**Subject: Response to NRC Request for Additional Information Regarding  
Extending Completion Times for Technical Specification 3.8.1  
(TAC Nos. ME5036, ME5037, and ME5038)**

TS-468 - Request for Extension to Completion Time for Technical Specification 3.8.1  
Required Action A.3, B.2, and B.5

### TVA Responses to NRC Request for Additional Information Questions

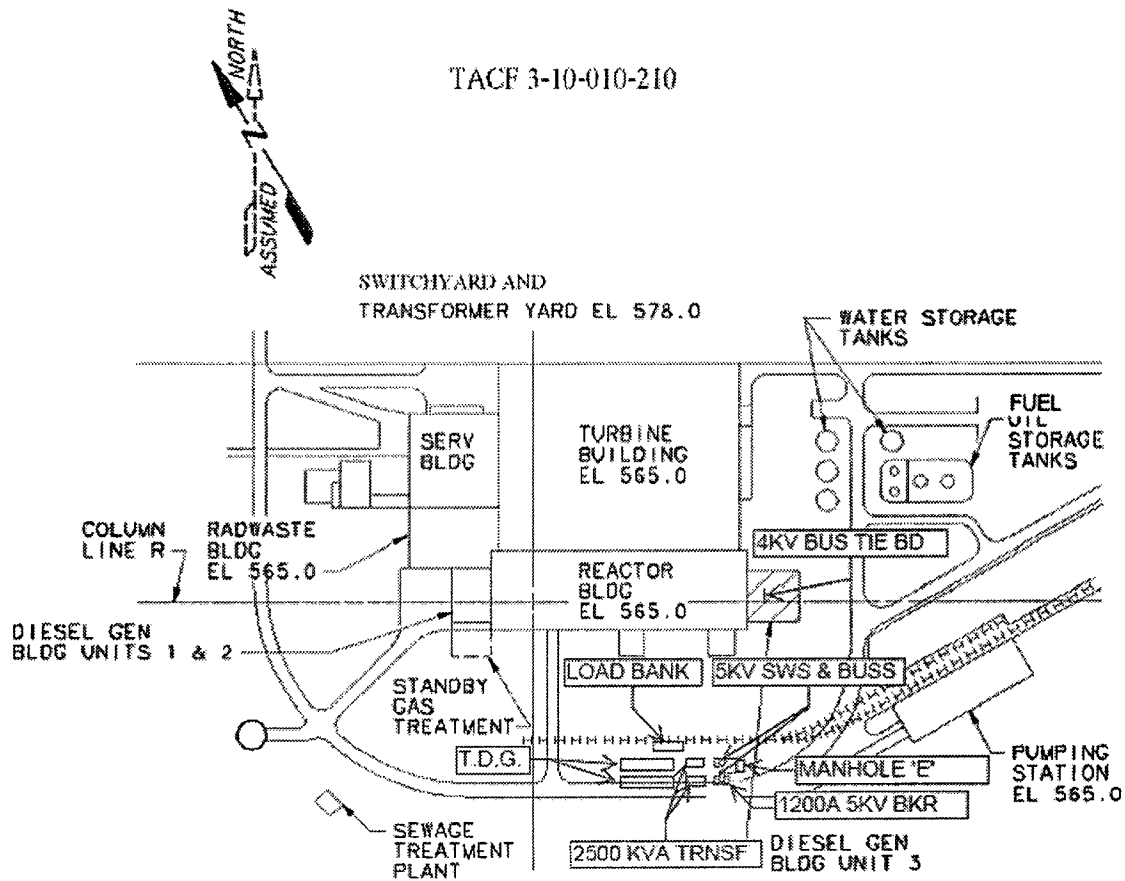
- a. *Provide estimated time it will take to manually start Temporary Diesel Generators (TDGs) and power a SDB, following a loss of all alternating current (AC) power.*
- b. *Also provide a summary of the analysis performed for coping with loss of AC power until TDGs are connected to the SDB.*

- a. Configuration, procedures and staffing will be such that the TDGs can be started and connected to the assigned 4 kV SDB within an estimated time of 30 minutes. The current Station Blackout (SBO) coping analysis of record contains the following functions which rely on AC power within the first hour:

- Start a second EECW pump within 1 hour.
- b. The TDGs will not be available to power the SDB in time to support the EECW function required within 8 minutes. Therefore, procedures will be revised such that the initial EECW pump is supplied by one of the remaining credited EDGs. TDG power will be available in time to support the remaining functions which rely on AC power during a SBO.

This will be NRC Commitment K.

**KEY PLAN**  
NTS

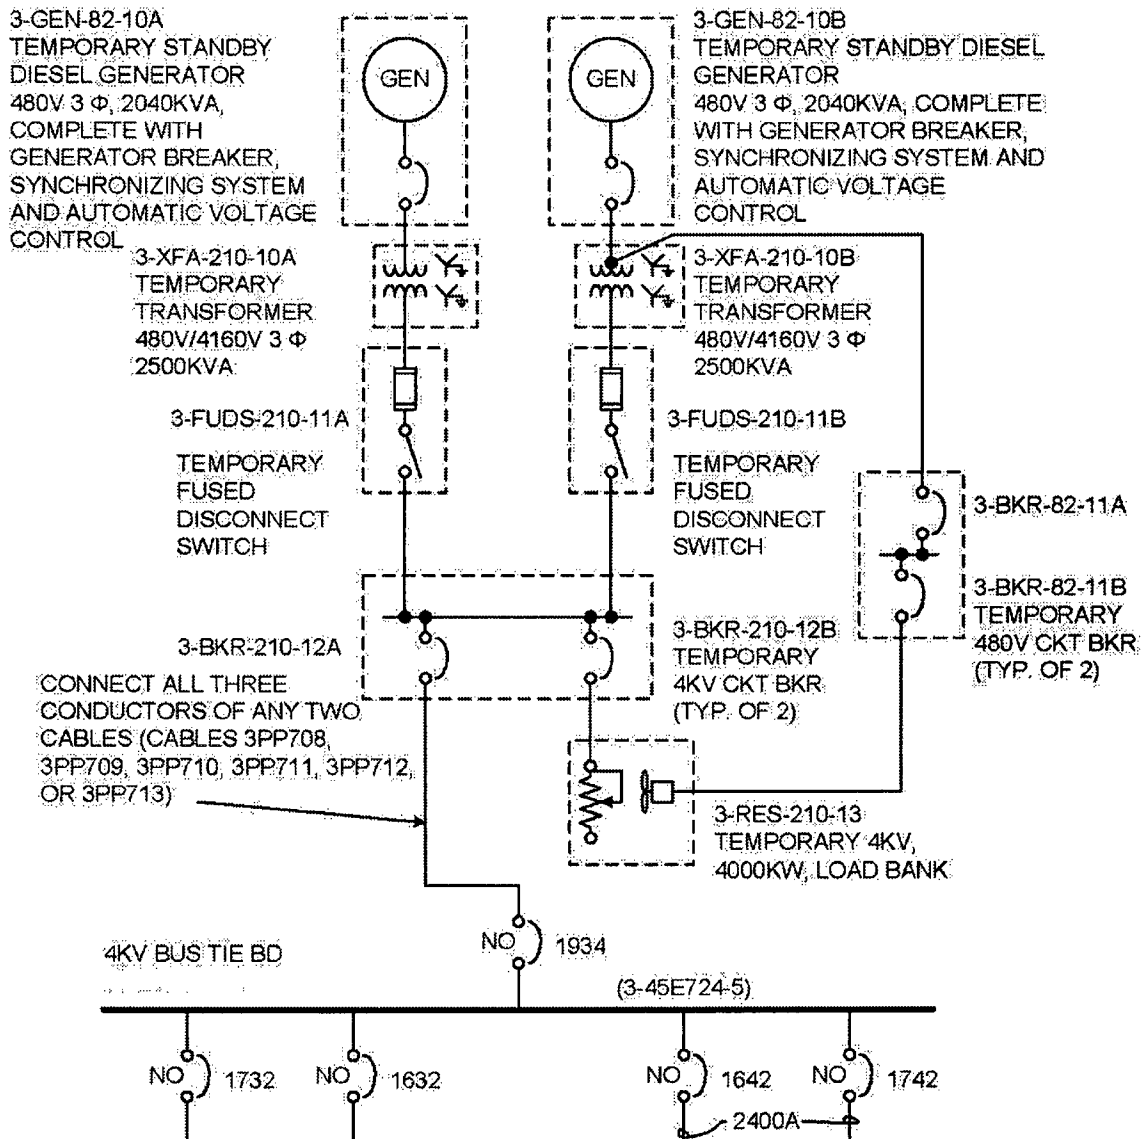
- a. Provide a sketch or drawing showing location of the TDGs, 480V-4160V step-up transformers, Manhole "E", and 4.16 kV Bus Tie Board.
- b. Provide the routing details of interconnecting cables. [From TDG to Bus Tie Board, clarified during teleconference with Electrical Branch on 01/13/11]
- c. Provide a single line diagram showing connection of TDGs to the Bus Tie Board.
- d. Confirm provisions will be made to keep the underground cables dry.
- e. Confirm that the existing 4.16 kV switchgear (Tie Board) rating will be adequate for two TDGs (each 1.62 MWe) with a combined rating of 3.24 MWe.

- a. This sketch shows the general location of the TDGs, Bus Tie Board, Diesel Fuel Oil Storage Tank, and their associated equipment.

- b. The two TDGs will be placed inside the plant's protected yard area, near Manhole "E." The TDG output is 480V AC. The two TDGs connect to the 4 kV Bus Tie Board via above-ground electrical cables, via the 480:4160 step-up transformer; then through Manhole "E" via underground cables. The underground cables are placed on cable trays. These cables terminate at the 4 kV Bus Tie Board, via breaker 1934.

The temporarily routed above-ground cables, from the TDGs to Manhole "E," will be protected from fire hazards and both pedestrian and vehicle traffic with barricades and signs. All cables used will be sized to handle the TDGs' capacity.
